Colton Joint Unified School District

Subject: District Comments on Response Letters dated March 1 and March 15, 2021, on the
Bloomington Center Project, 10951 Cedar Avenue, Bloomington

Subject: Response to Notice of Intent to Adopt Mitigated Negative Declaration for the
Bloomington Center Project, 10951 Cedar Avenue, Bloomington

Subject: Response to Colton Joint Unified School District Comments on the Bloomington Center Project the Draft Initial Study-Mitigated Negative Declaration

Figure A-1 Storage Tank Locations

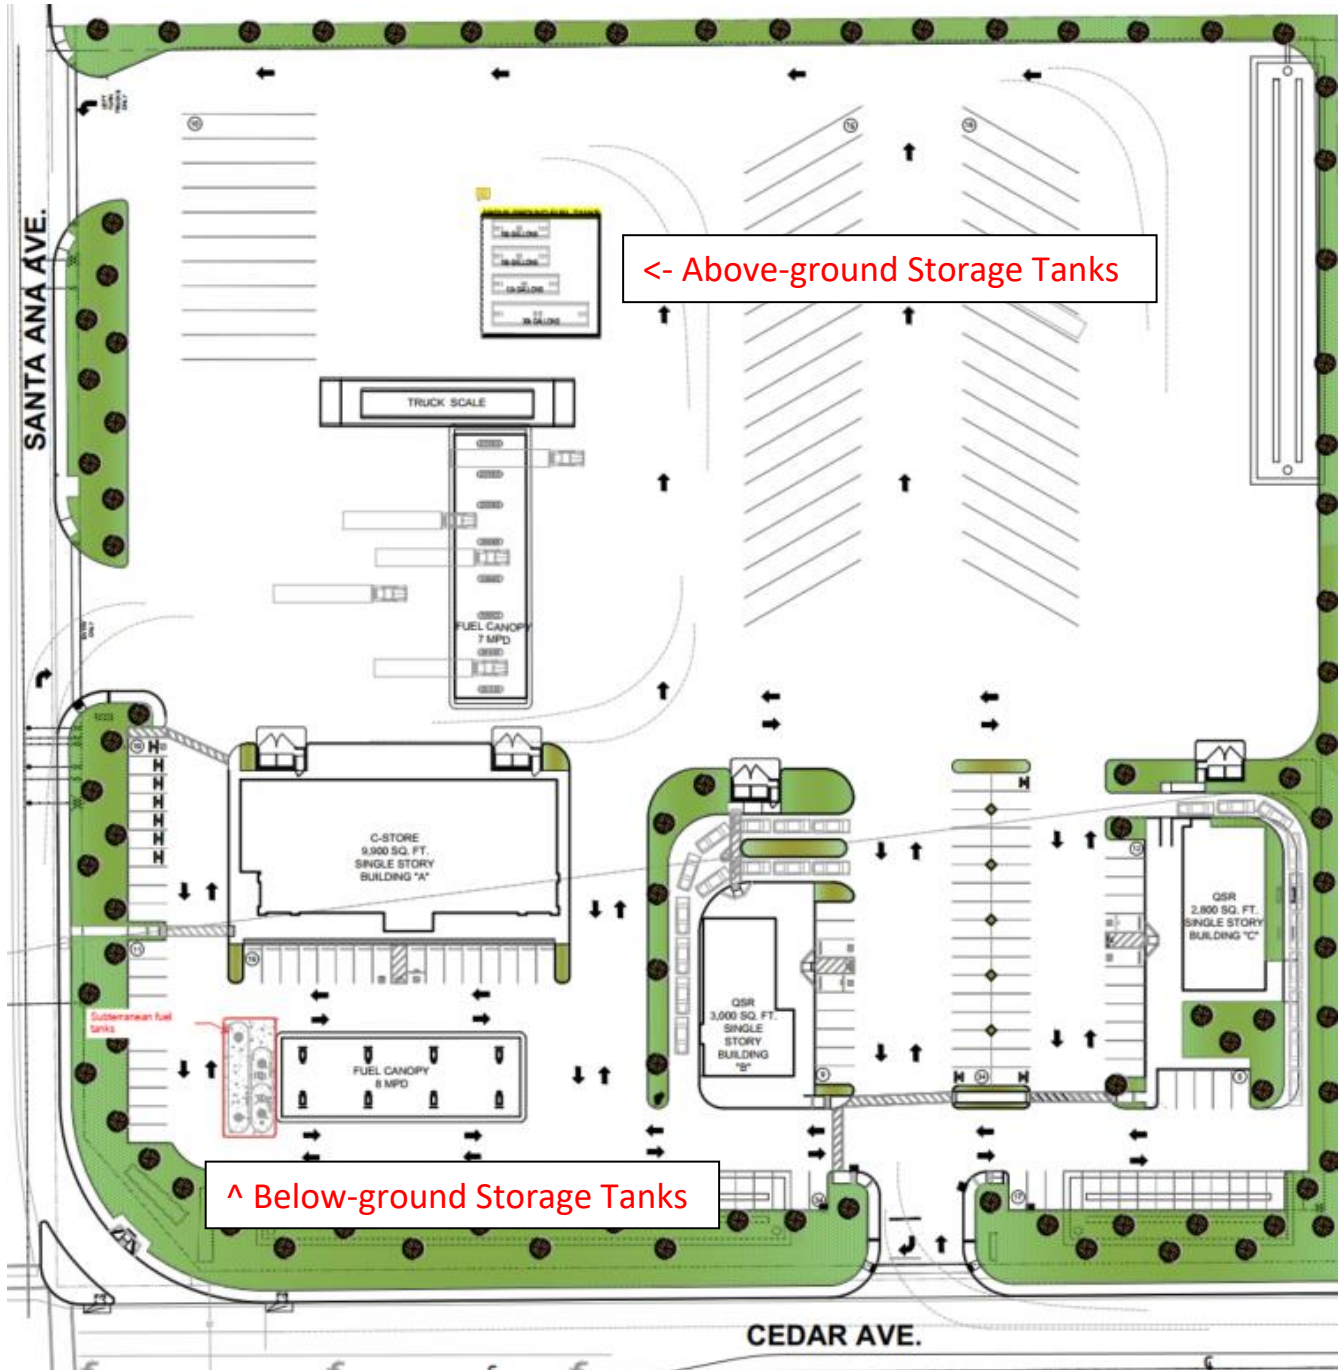
- **Page 2.** Proposed Project includes eight fuel dispensers and seven diesel bays. The Project Description states that fuel tanks would be provided on lot 6. However, it is unclear from the Site Plan (Figure 3) where the specific location of these tanks will be. The Project Description should include a discussion of the location of these fuel tanks, and project design features and maintenance measures put in place to ensure that such tanks are safe from cracks, breaks, and leaks. Additional specific questions include:

- Will these tanks be above ground or subterranean?
- **Page 2.** The description for proposed lots 4 and 5 is “no development.” However, the Site Plan shows that these areas would be used for vehicular circulation with truck parking spaces provided on the south side of lot 6. If no development is proposed for these lots, will these lots remain unpaved and in their current state? If this is not the case, then the Project Description should describe what will occur within these lots.

See Figure A-1, below, for a site plan that displays the current positioning of the fuel tanks. Some tanks will be above ground on the eastern portion of the site, and would be screened from surrounding uses. Other tanks would be underground located next to the fueling stations on the western portion of the site. In regards to maintenance measure, the project would adhere to the Certified Unified Program Agency requirements (CUPA is the Hazardous Materials Division of the San Bernardino County Fire Department).

Figure A-1 Storage Tank Locations

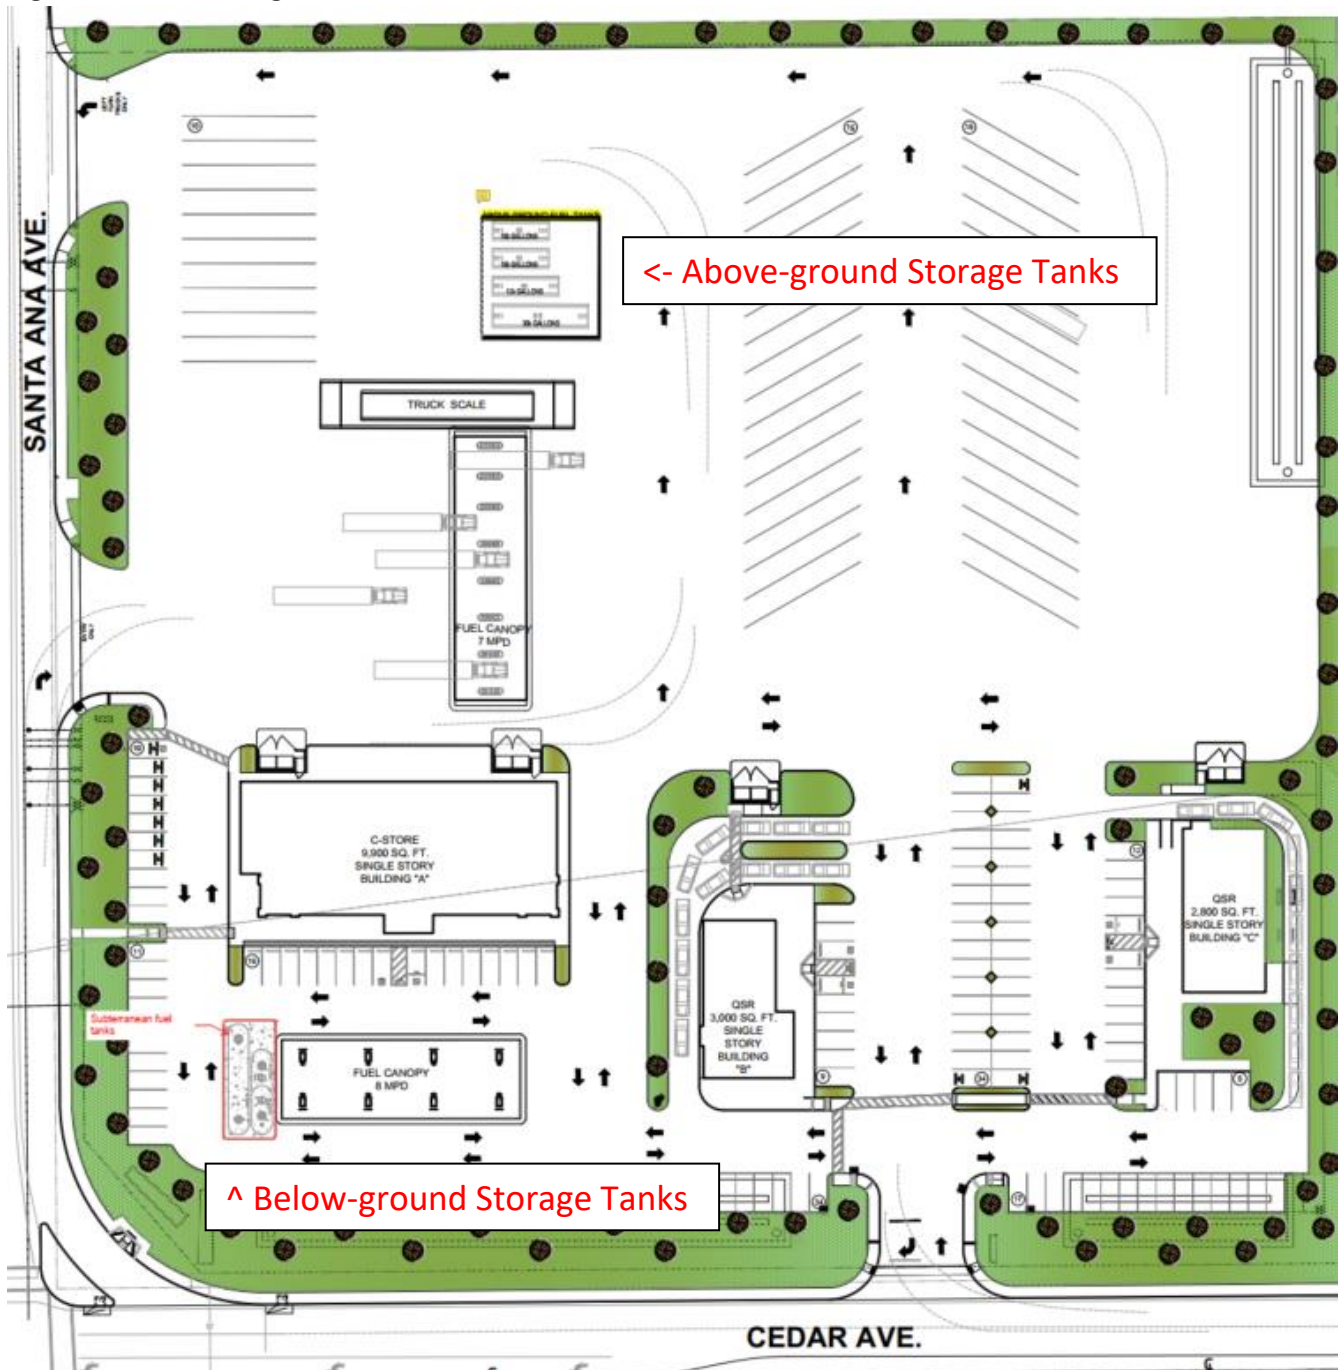
- **Page 2.** Proposed Project includes eight fuel dispensers and seven diesel bays. The Project Description states that fuel tanks would be provided on lot 6. However, it is unclear from the Site Plan (Figure 3) where the specific location of these tanks will be. The Project Description should include a discussion of the location of these fuel tanks, and project design features and maintenance measures put in place to ensure that such tanks are safe from cracks, breaks, and leaks. Additional specific questions include:
 - Will these fuel tanks hold fuel for both the multi-fuel pumps on the west side of the Proposed Project and the diesel tanks toward the east side of the Proposed Project? Or are there separate tanks proposed for the west side of the Project Site?
 - Will these tanks be above ground or subterranean?

- **Page 2.** Proposed Project includes eight fuel dispensers and seven diesel bays. The Project Description states that fuel tanks would be provided on lot 6. However, it is unclear from the Site Plan (Figure 3) where the specific location of these tanks will be. The Project Description should include a discussion of the location of these fuel tanks, and project design features and maintenance measures put in place to ensure that such tanks are safe from cracks, breaks, and leaks. Additional specific questions include:
 - Will these fuel tanks hold fuel for both the multi-fuel pumps on the west side of the Proposed Project and the diesel tanks toward the east side of the Proposed Project? Or are there separate tanks proposed for the west side of the Project Site?
 - Will these tanks be above ground or subterranean?

See Figure A-1, below, for a site plan that displays the current positioning of the fuel tanks. Some tanks will be above ground on the eastern portion of the site, and would be screened from surrounding uses. Other tanks would be underground located next to the fueling stations on the western portion of the site. In regards to maintenance measure, the project would adhere to the Certified Unified Program Agency requirements (CUPA is the Hazardous Materials Division of the San Bernardino County Fire Department).
